SECTION 009113 - **ADDENDA #4**

A. Project Name: Joplin Public Park.

F. Date of Addendum: August 21, 2015.

Number
G002

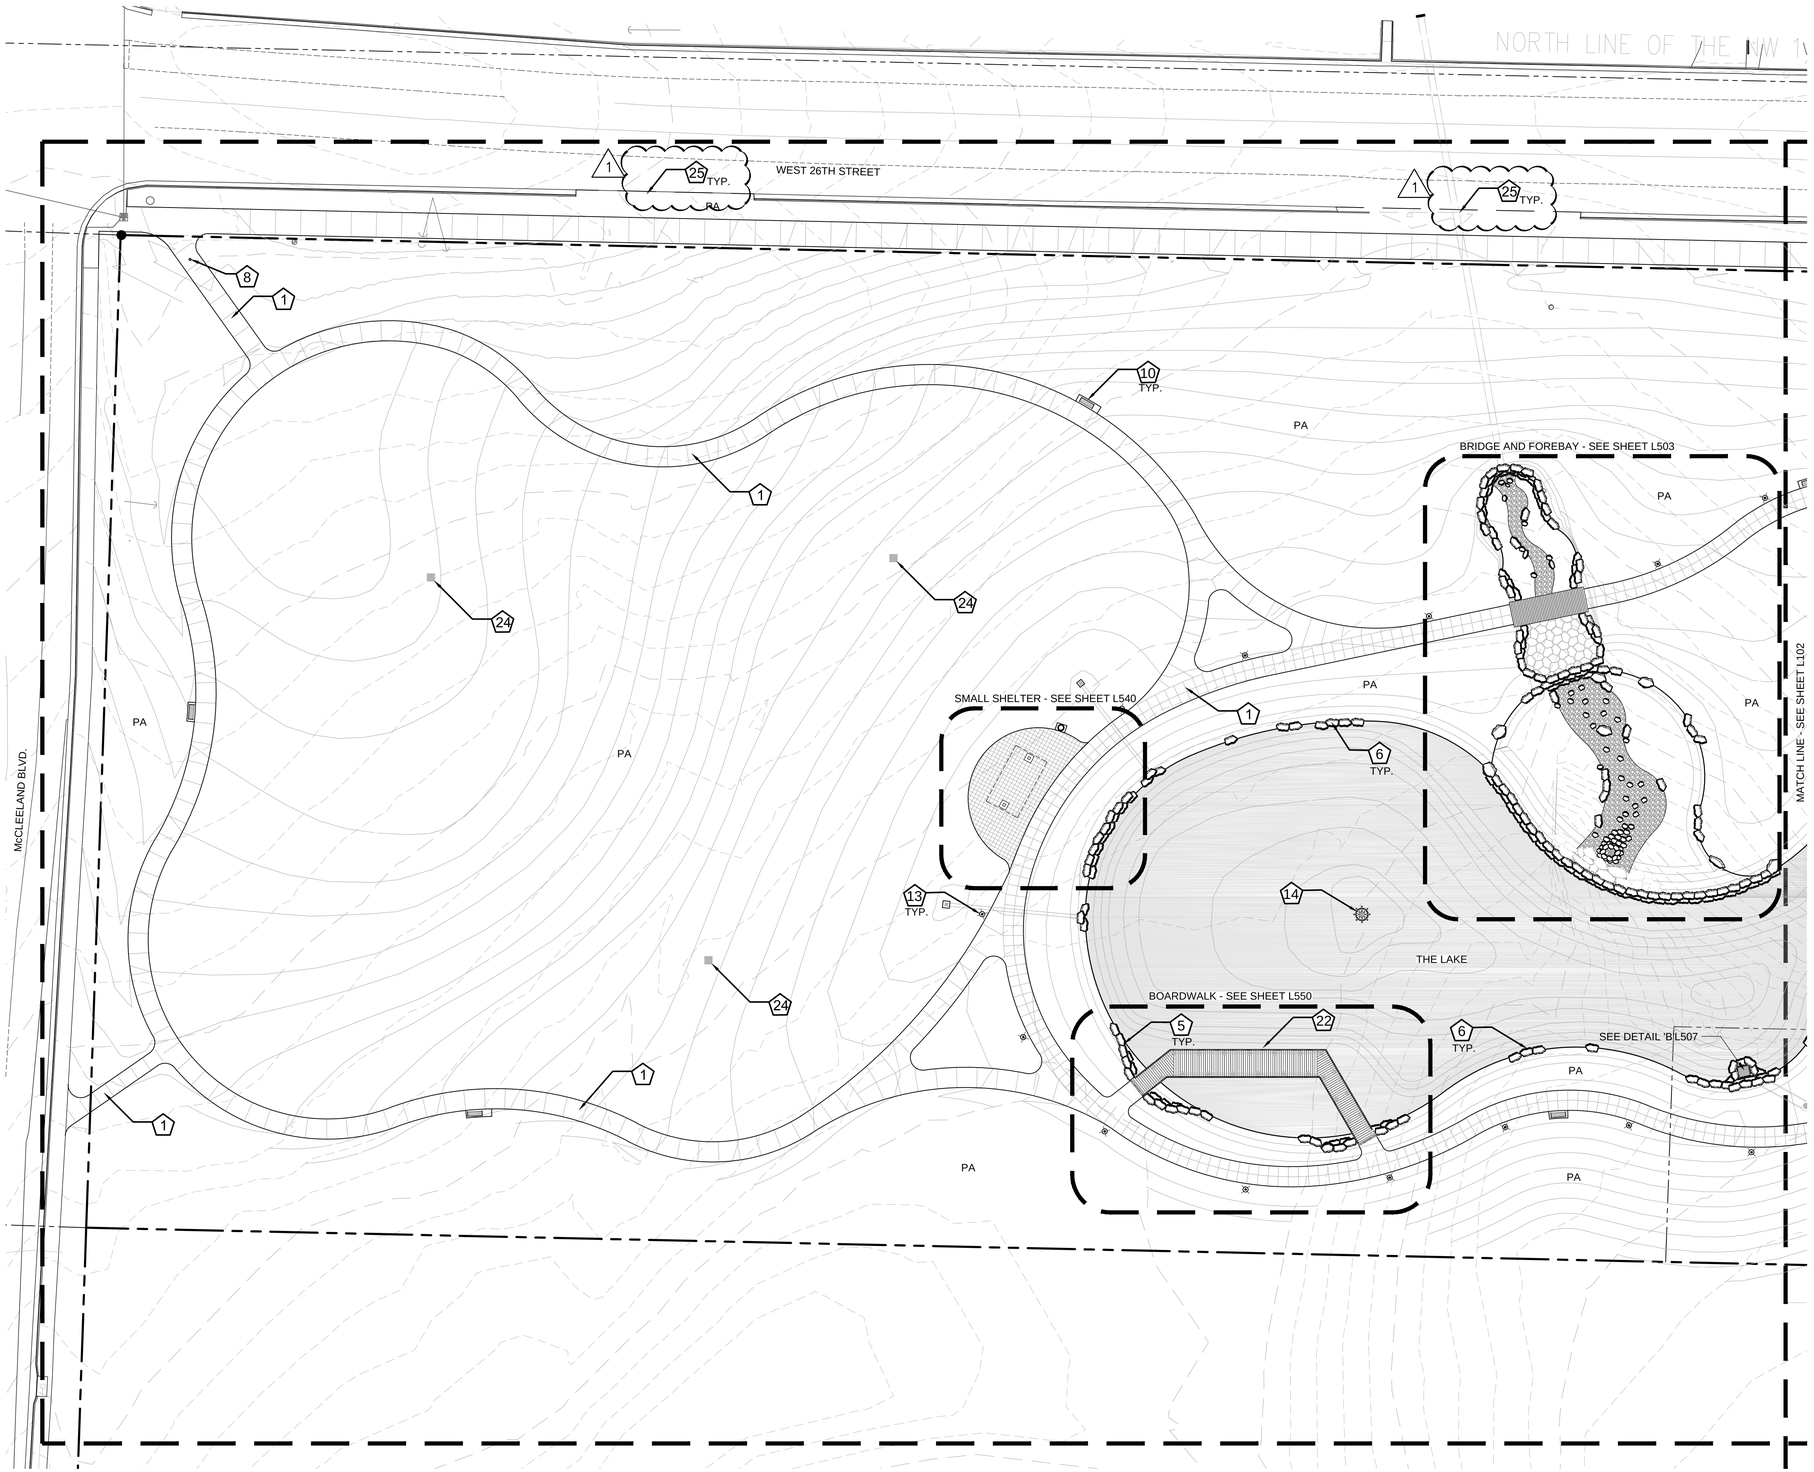
A. Sheet G002- Additional Notes and Legends.

1. Revision to Material Legend.

25 **CONCRETE CURB AND GUTTER**
SEE DETAIL ON SHEET C500

26 **2" ASPHALT MILL AND OVERLAY**
SEE DETAIL ON SHEET C500

27 **ASPHALT PAVEMENT**
SEE DETAIL ON SHEET C500

28 **CONCRETE WHEELSTOP**
SEE DETAIL ON SHEET C500

29 **WHITE PAVEMENT STRIPE**
4" WIDTH FOR PARKING STALLS
CROSSWALKS PER CITY STANDARDS

30 **BLUE PAVEMENT STRIPE**
4" WIDTH FOR HANDICAP PARKING STALLS

Number
L101

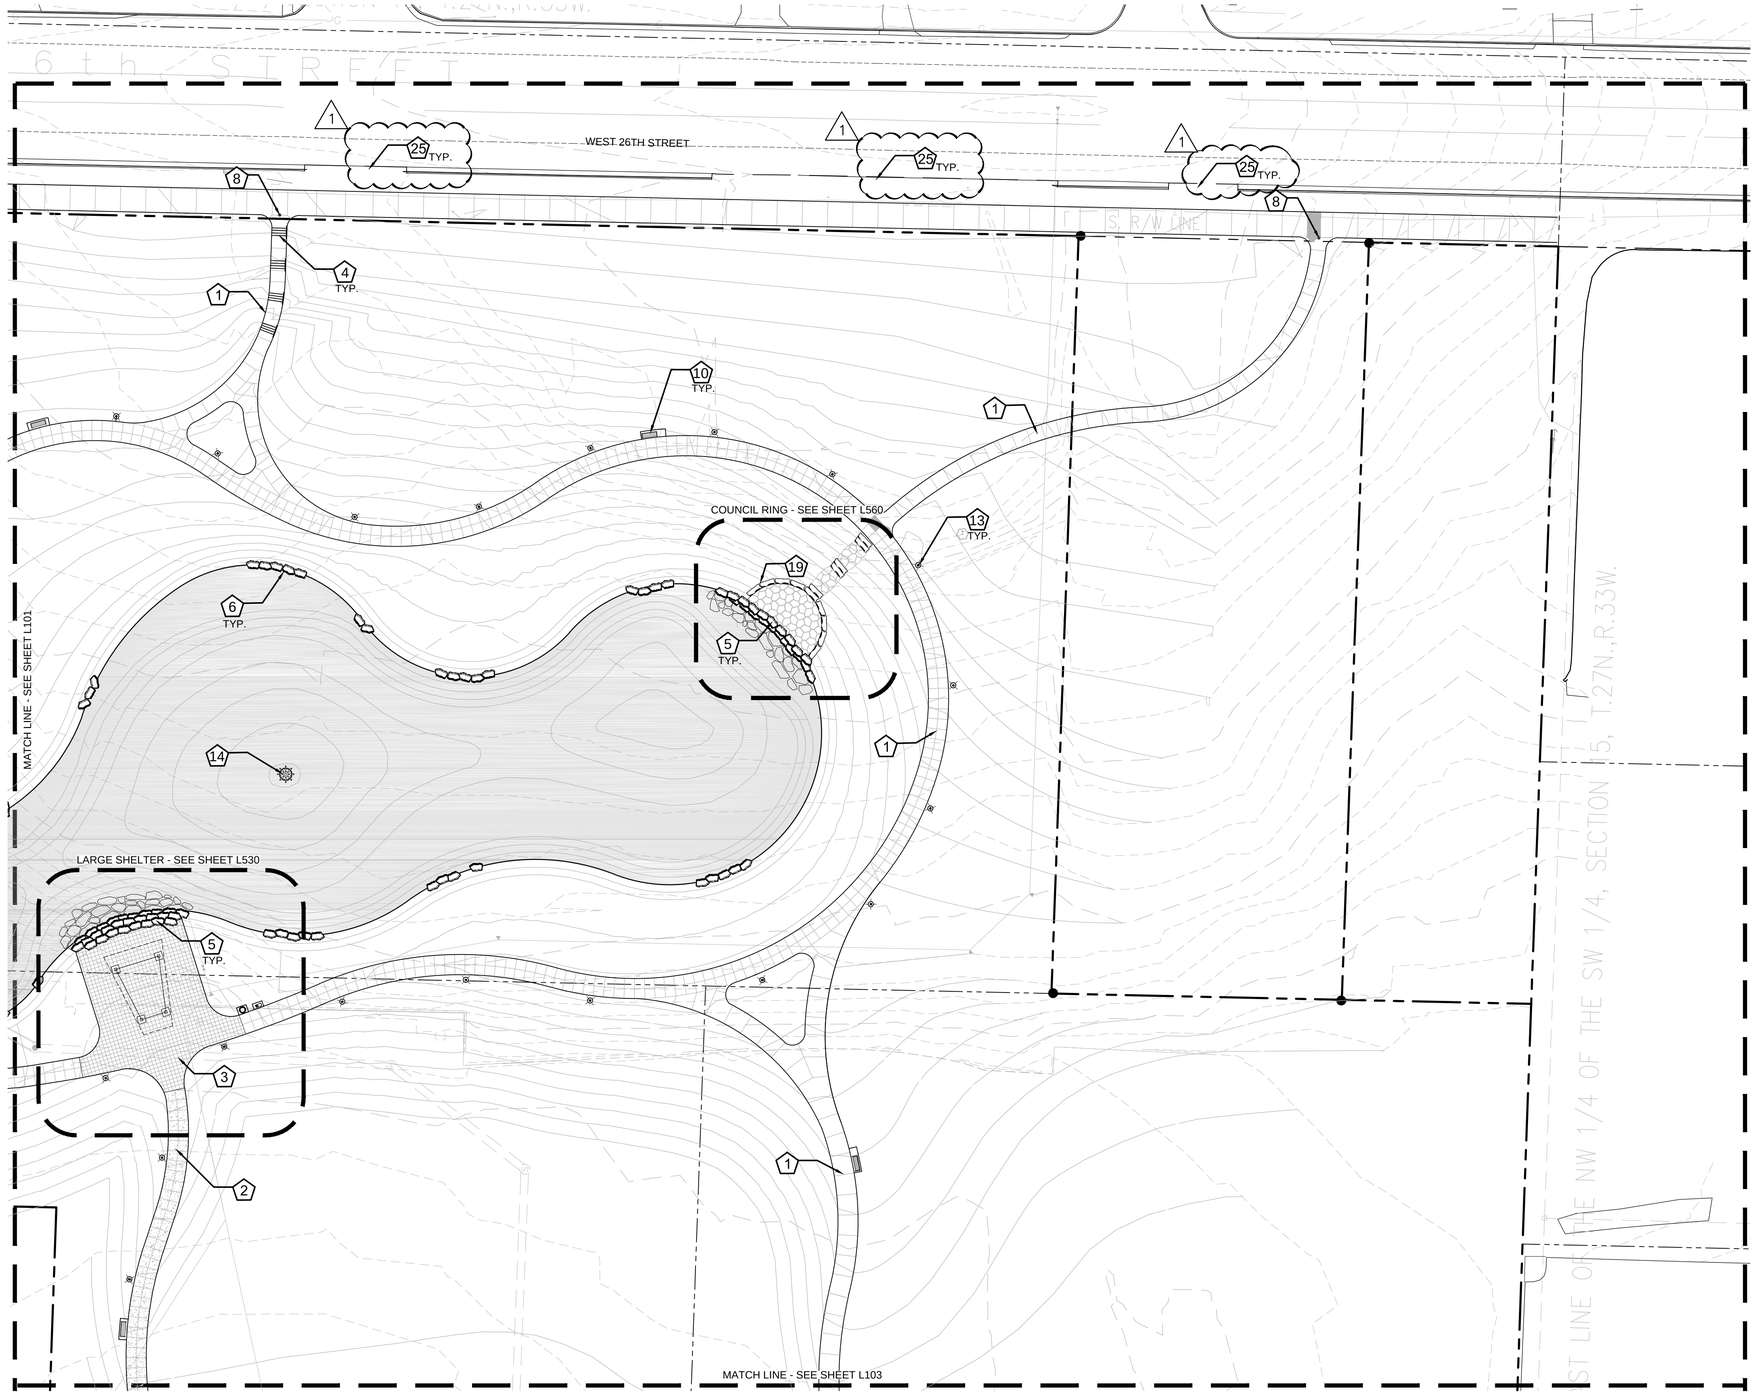
B. Sheet L101- Materials and Notes, Area A.

1. Callout for concrete curb and gutter.

Number
L102

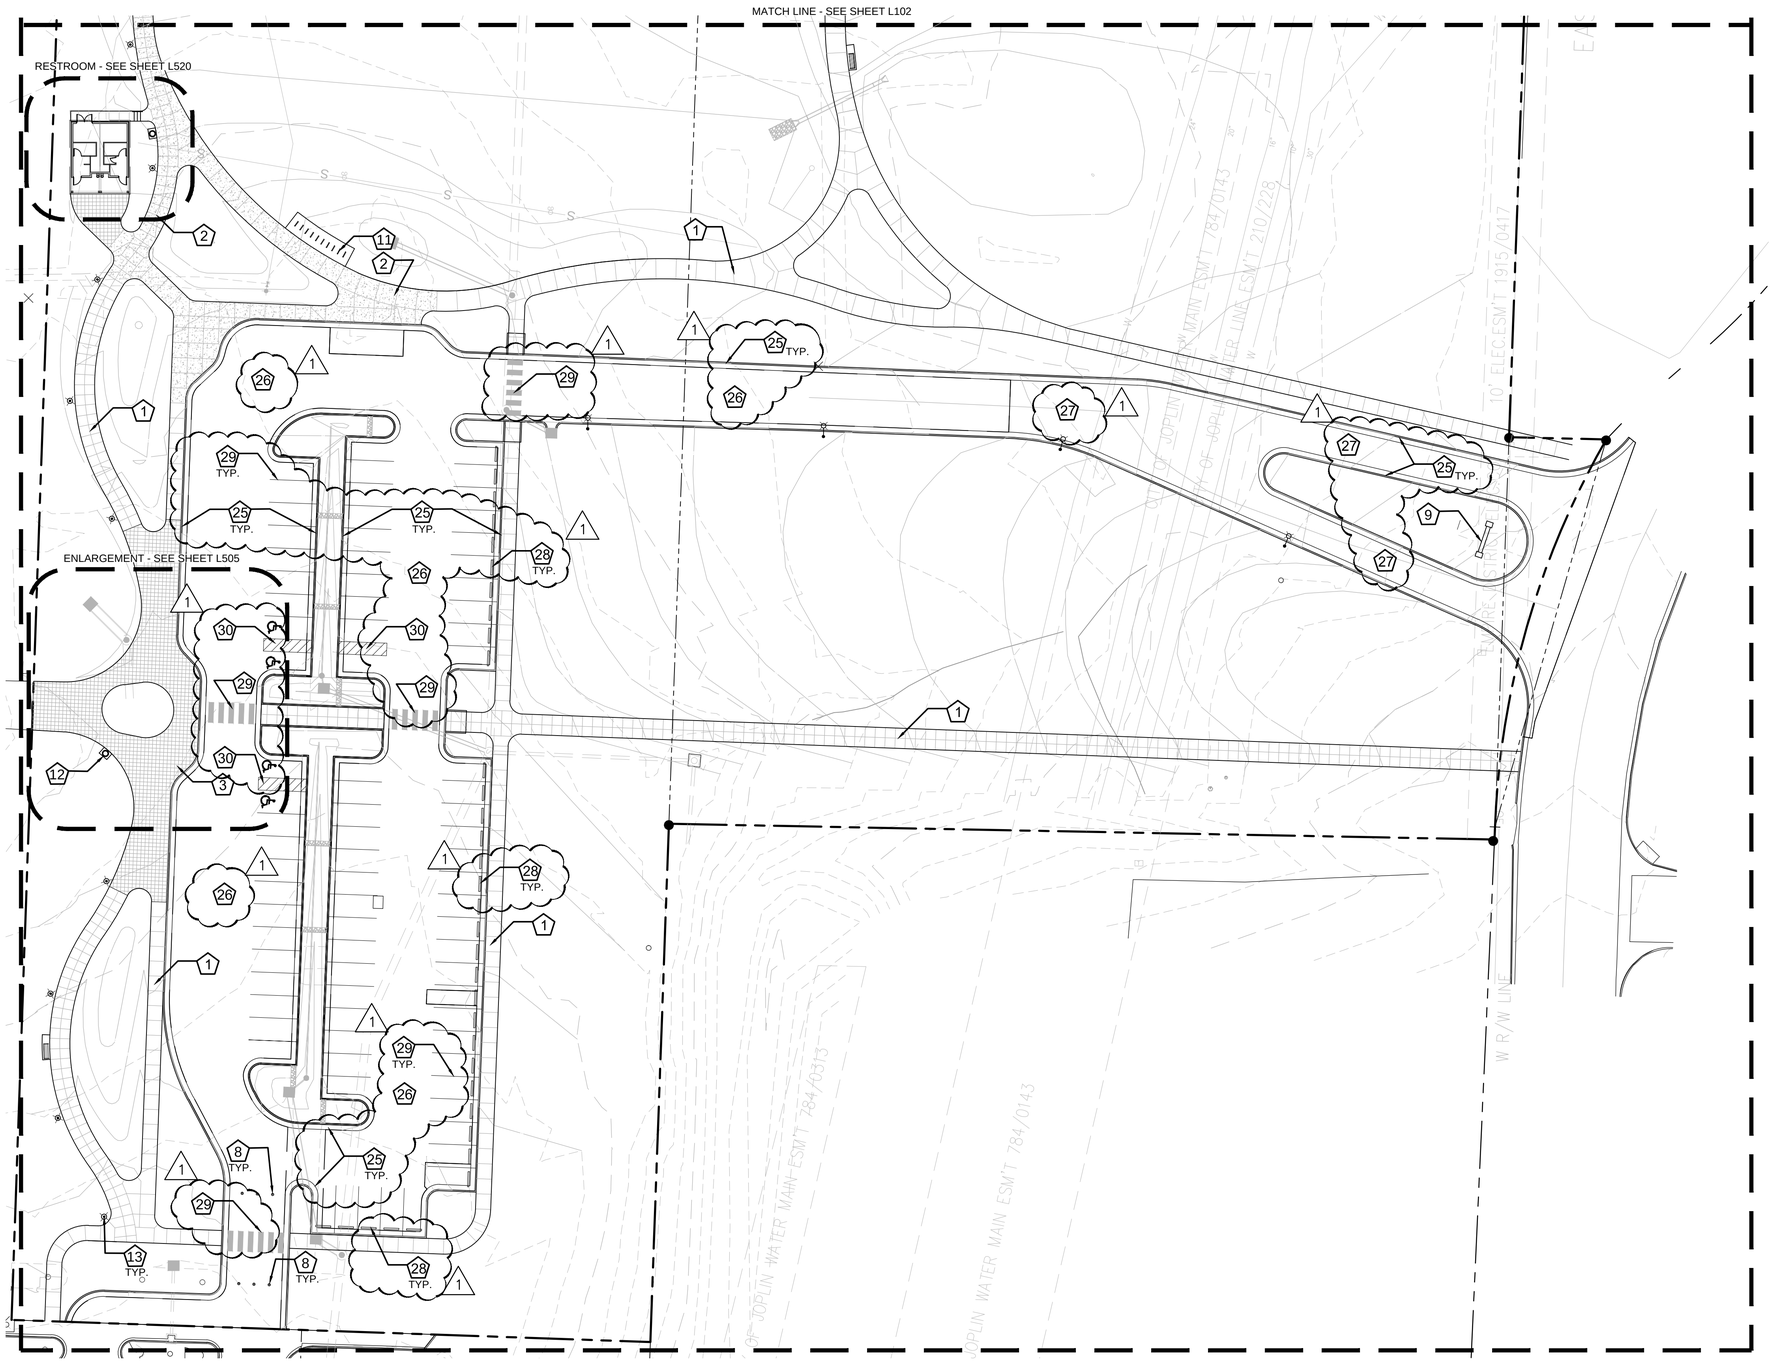
C. Sheet L102- Materials and Notes, Area B.

1. Callout for concrete curb and gutter.

PAVEMENT REPAIR OF CITY STREETS

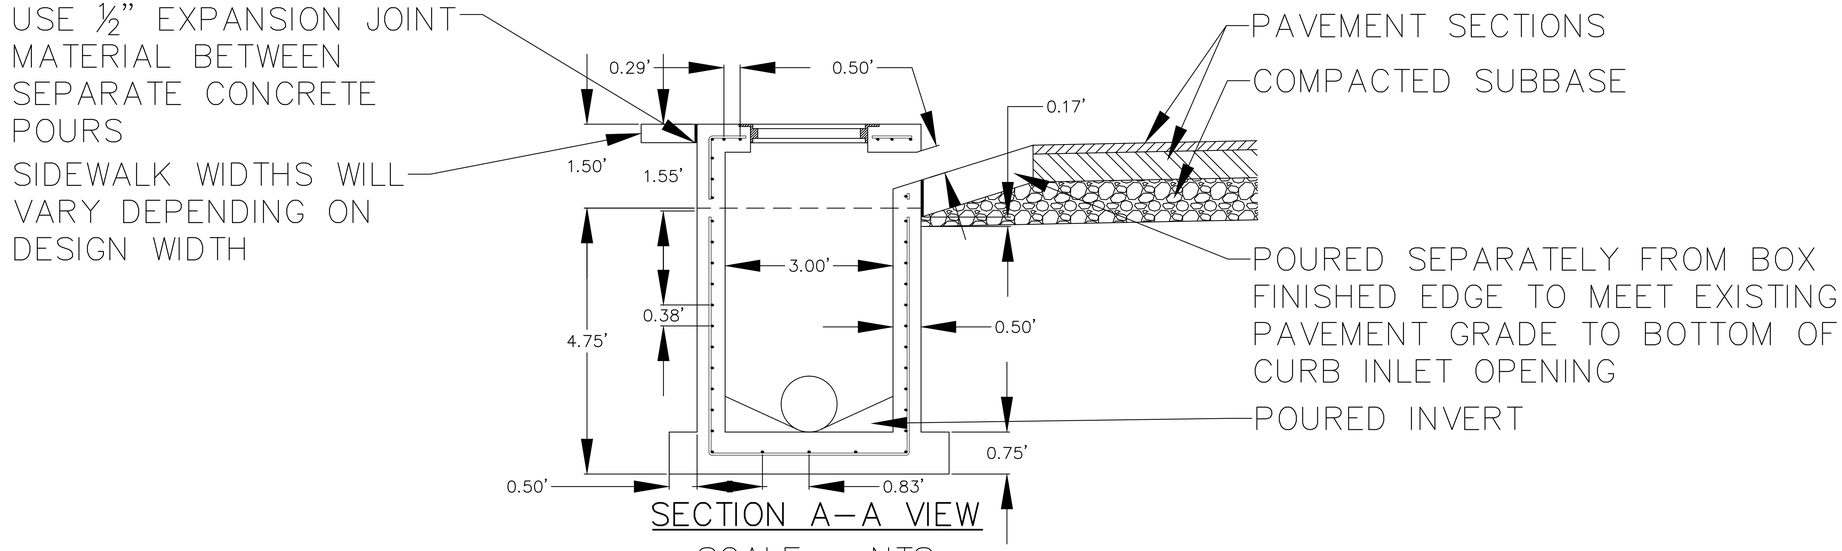
1. City Standard Detail, Type C Inlet, to supercede detail on sheet C500.
2. City Standard Detail, Pavement Repair, to supercede detail on sheet C500.
